FINAL
Environmental Impact Report
Del Hombre Apartments Project
Contra Costa County, California

State Clearinghouse Number: 2018102067

Date: May 15, 2020

SECTION 2: RESPONSES TO WRITTEN COMMENTS

Photos 1 and 2. Oak titmouse (left) and black phoebe (right) on the site of the proposed project, 16 October 2019. Oak titmouse is a special-status species.

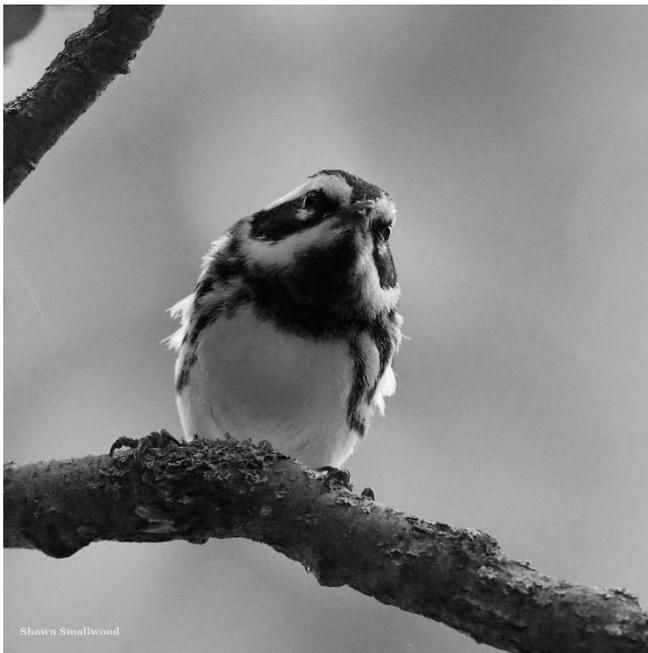
A reconnaissance-level survey was performed by consulting biologist on 7 January 2019, but no details were provided on start time or survey duration. The biologist misidentified eastern gray squirrel as California ground squirrel (Photo 7). Species misidentifications should be anticipated, especially by anyone young in their career, but the consulting firm should provide oversight to correct such errors. California ground squirrels look very different from eastern gray squirrels, and they are very different ecologically. Finding California ground squirrels in an interior wooded patch would have been unlikely. The only squirrels at the site are eastern gray squirrels.

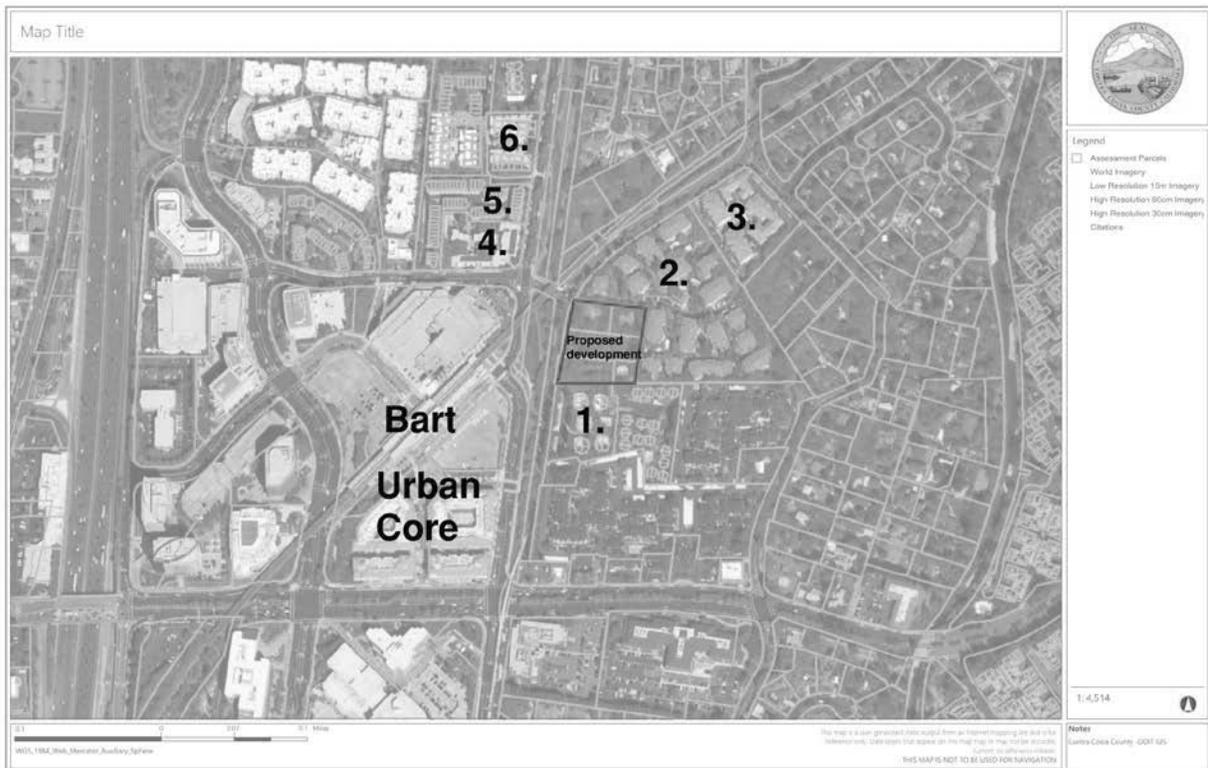
b. Variance to eliminate the 10-foot setback requirement from a public road.

Neighboring lots have a variety of setbacks set key map below:

- 1) Del Hombre Condominiums: 16' to the carport structures
- 2) Avalon Walnut Ridge on Las Juntas: ranging from 16' to 30' adjacent the proposed site.
- 3) Avalon Walnut Ridge on Las Juntas between Santos Lane and Cherry Lane: ranging from 8' to 12'

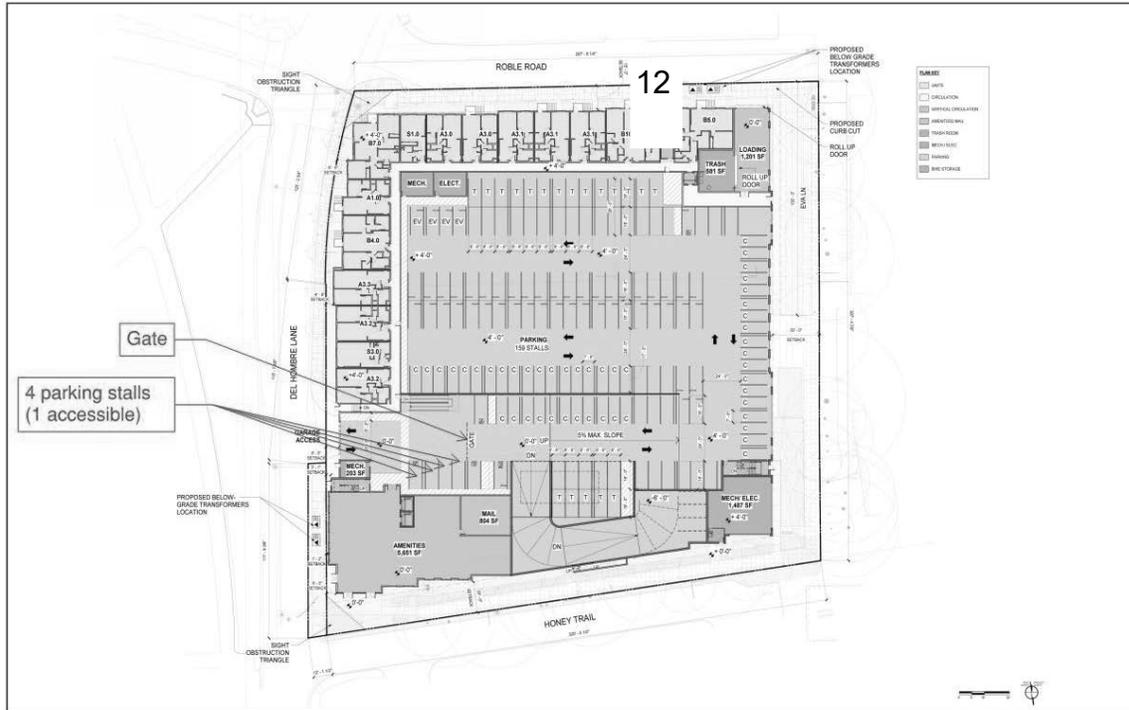
It appears that there is a loading dock off Roble Road. Given the likely turnover of the apartments it would be expected that there would be several move ins/outs per week. Given the narrow roads and inability to traverse Del Hombre Lane without passing the project it should be confirmed that facilities provided are sufficient that all moving vehicles and larger delivery vehicles are able to be pulled entirely off the roads.

It is noted that the mail room is at the southwest corner of the site. It is unclear if the drop off loading zone at this location would be adequate for parcel delivery trucks as well as pedestrian pick up drop off. This could lead to double parking at a location very close to the main entry and associated and the intersection with Honey Trail. This could be a safety hazard.

Exhibit 3.3-2
Tree Removal Plan

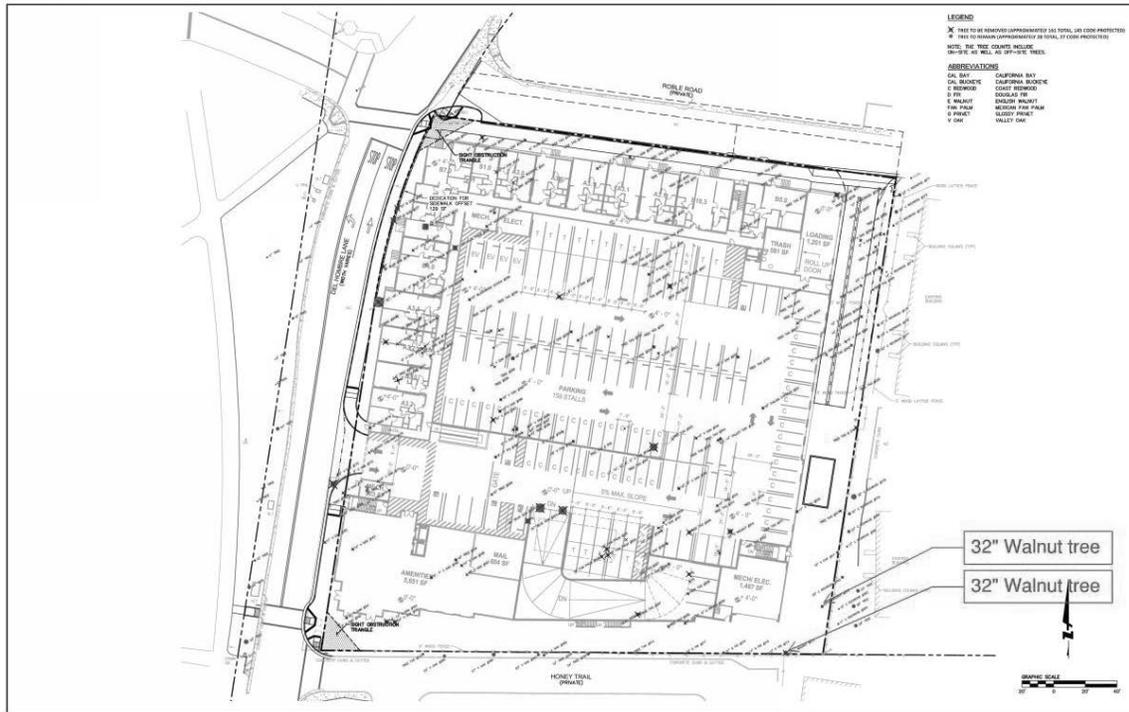
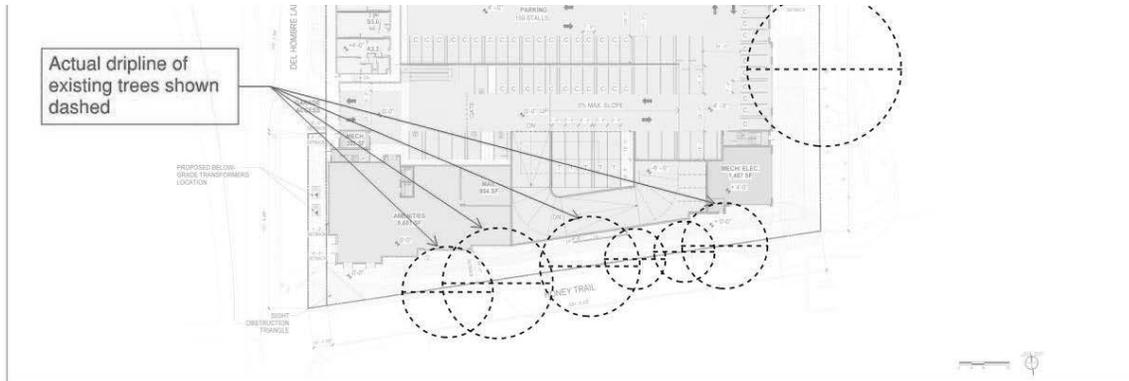
- i. It is noted that all trees on site are to be demolished. This certainly seems appropriate for the Blue Gums in the center of the site and a number of trees would need to be demolished for any development to take place.
- ii. There are two large walnut trees at the edge of the site that, given the proposed footprint, appear to be able to be protected in place. No justification within the DEIR has been provided for their removal.

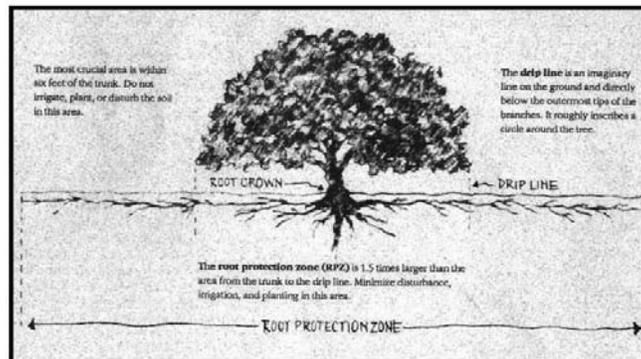
- b. Trees on adjacent properties
 - i. Immediately south of the southern property line are a series of valley oaks ranging from 15" to 27". These have canopies that extend both north and south and provide visual amenity, shade and habitats for the local wildlife.

Valley Oaks are particularly sensitive to disturbance in soil compaction (construction traffic, scaffolding, pavement), hydrology (changed stormwater flows and groundwater conditions), and mechanical interference (shoring and trenching) within their root zones. The root zone can extend significantly further than their dripline – typically 1.3 to 1.5 times the diameter of the dripline. (Reference the California Wildlife Foundation)

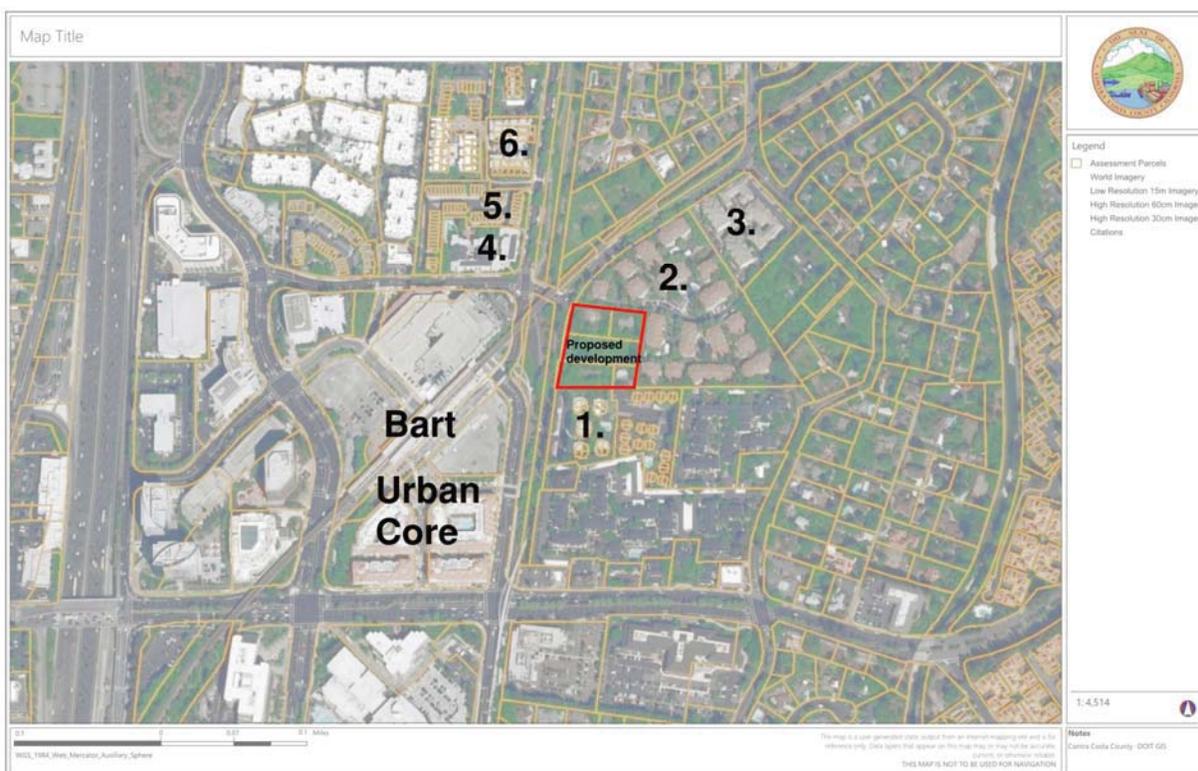
b. Variance to eliminate the 10-foot setback requirement from a public road.

Neighboring lots have a variety of setbacks set key map below:

- 1) Del Hombre Condominiums: 16' to the carport structures
- 2) Avalon Walnut Ridge on Las Juntas: ranging from 16' to 30' adjacent the proposed site.
- 3) Avalon Walnut Ridge on Las Juntas between Santos Lane and Cherry Lane: ranging from 8' to 12'

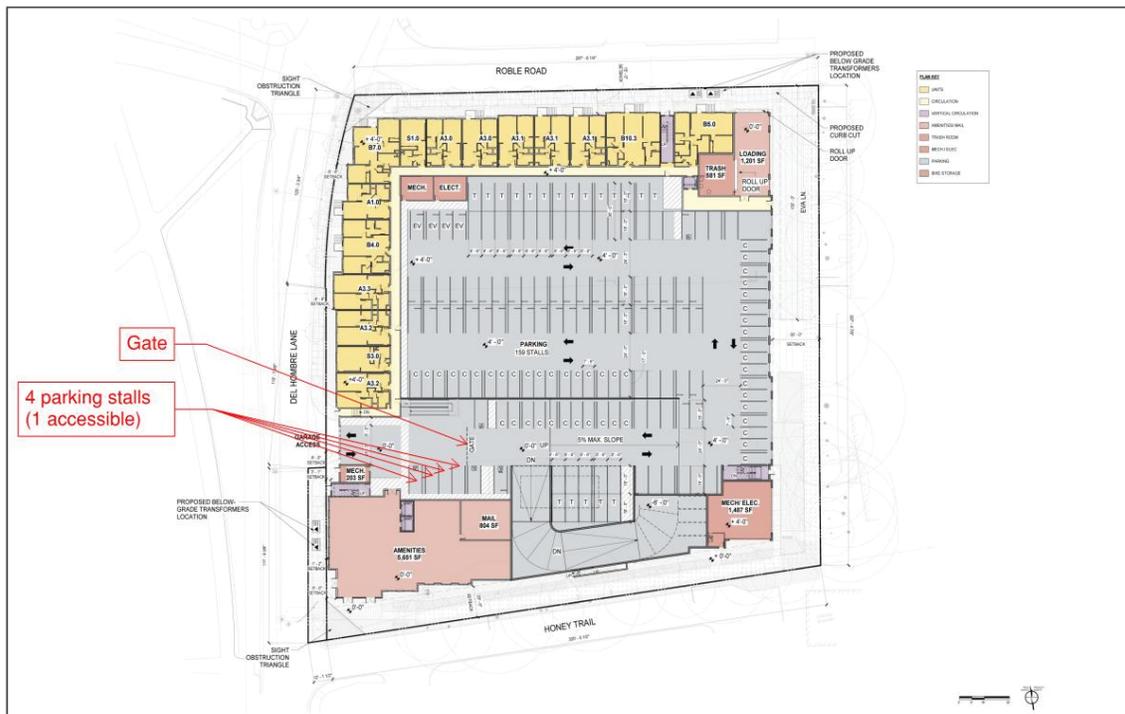
It is noted that the mail room is at the southwest corner of the site. It is unclear if the drop off loading zone at this location would be adequate for parcel delivery trucks as well as pedestrian pick up drop off. This could lead to double parking at a location very close to the main entry and associated and the intersection with Honey Trail. This could be a safety hazard.

Exhibit 3.3-2
Tree Removal Plan

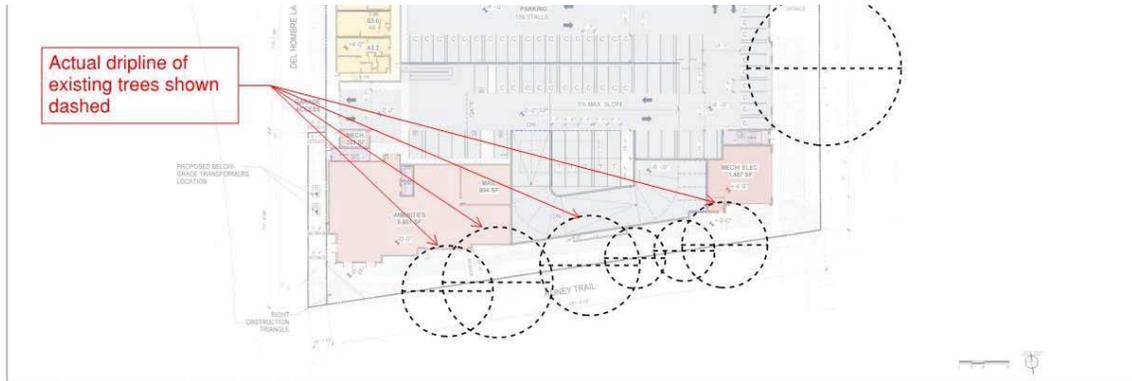
- i. Immediately south of the southern property line are a series of valley oaks ranging from 15" to 27". These have canopies that extend both north and south and provide visual amenity, shade and habitats for the local wildlife.
